## CITY OF GARDEN CITY

**File Number: PUDFY2021-0001**  
**Location: 116, 118, and E. 33<sup>rd</sup> Street**  
**Applicant: Jeff Hatch**  
**Planning and Zoning: June 16, 2021 moved to July 21, 2021**  
**Design Review Committee Pre-Application Conference: June 21, 2021**  
**Design Review Formal Hearing: July 19, 2021**  
**City Council: July 12, 2021 moved to August 9, 2021**

Staff Report  
 Prepared by Hanna Veal

SOUTHWEST ELEVATION

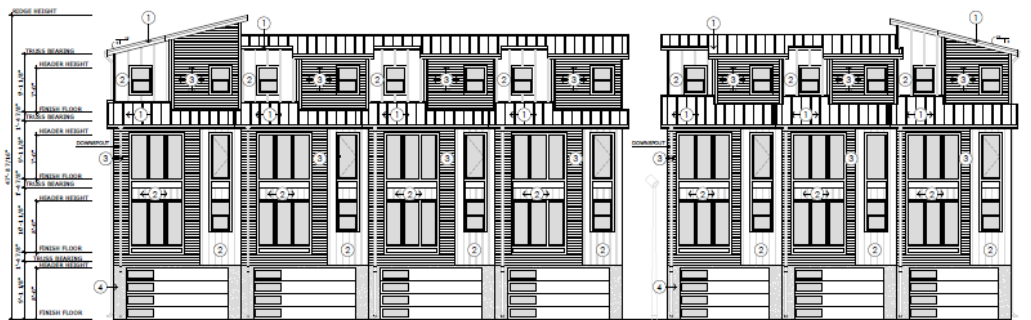
Committee comment for pre-application conference: "Perimeter landscaping along the Southeast property line is acceptable so long as there is additional structural design to help meet the intent of perimeter landscaping." The southwest façade has changed from the original proposal by including additional architectural features. These features include varying materials, wire mesh accents and a public art wall the corner nearest to 33rd St. The perimeter landscaping has not changed. The applicant has not officially requested a waiver for perimeter landscaping standards; however, staff has included it in the decision document.
